Access Compliance Report

Public Rights-of-Way

(Curb Ramps)

Intersection ID: 6992	Main Street: BLUE_HAMPTON_LN	Cross Street: GRAHAM_MEADOW_DR	Location: S
ADA ID: 1F31297C2515	Ramp Type: Perp	Initial Pass/Fail: Pass	Overall Compliance: No
Codes/Mitigation Info/Possible Solution			Severity Score: 15
			Field Measurements/Component Compliance

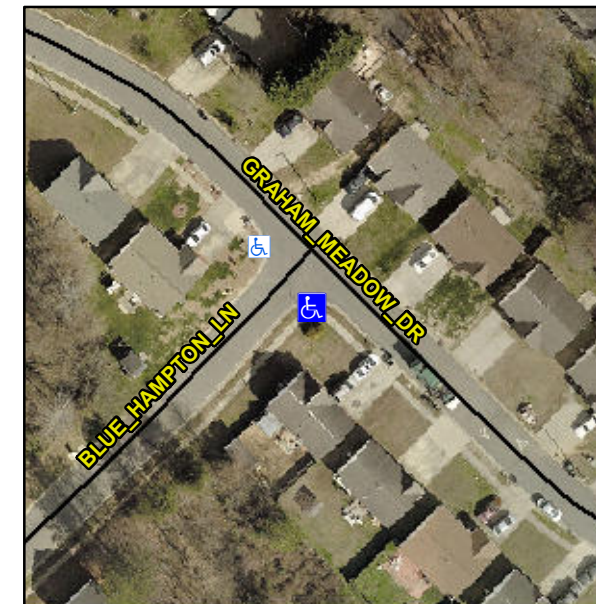
**Not Found, R304.2.2-Perp, R304.3.2-
Para, R304.5.3, R305, R304.5.4**

**Remove & Replace Entire Ramp.
Remove & Replace Gutter.**
